Notice of Decision

Site Plan Review

SP-27-22

PROJECT NUMBER: 221362
JACKSON SUBARU OF ALBANY

SHEET TITLE:
PROPOSED SITE PLAN

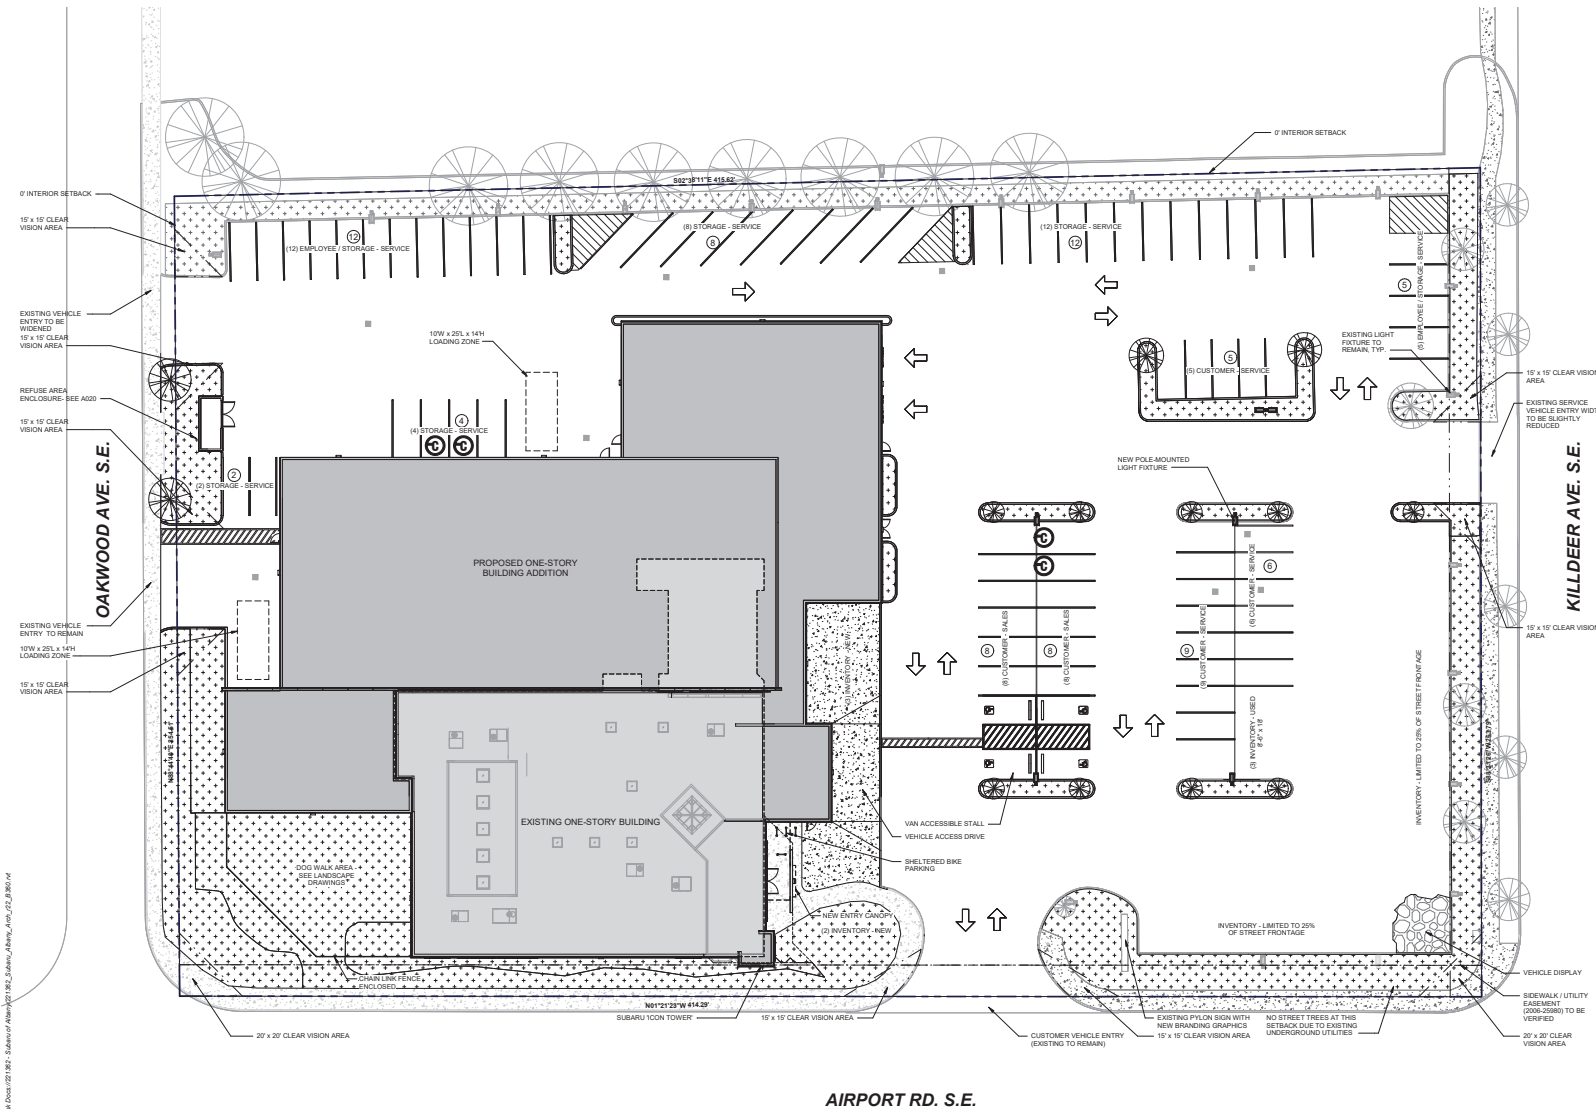
- Condition 1** Prior to the issuance of building permits, the applicant must submit a revised site plan that demonstrates the minimum parking spot requirements can be met (ADC Table 9.020-1).

- Condition 2** Prior to the issuance of building permits, the applicant must demonstrate details of required planter bays at each end of the parking lot (ADC 9.150(1)).

- Condition 3** Prior to issuance of building permits, the applicant will need to provide detailed plans regarding the number of proposed bicycle spots and the location of the covered bicycle spots.

- Condition 4** Prior to issuance of building permits, the applicant will need to provide detailed plans regarding the proposed lighting per ADC 9.120(14).

- Condition 9** Prior to issuance of a Building Permit, the applicant shall dedicate right of way along the site's frontage on Airport Road. The new right-of-way line shall be located at least six inches behind the back of sidewalk. A property line radius will be needed at the north and south end of the site at Killdeer Avenue and Oakwood Avenue.

4. The FDC shall be placed in an approved location. Fire's first choice is on the west side of the Killdeer entrance, as close as possible to existing hydrant.
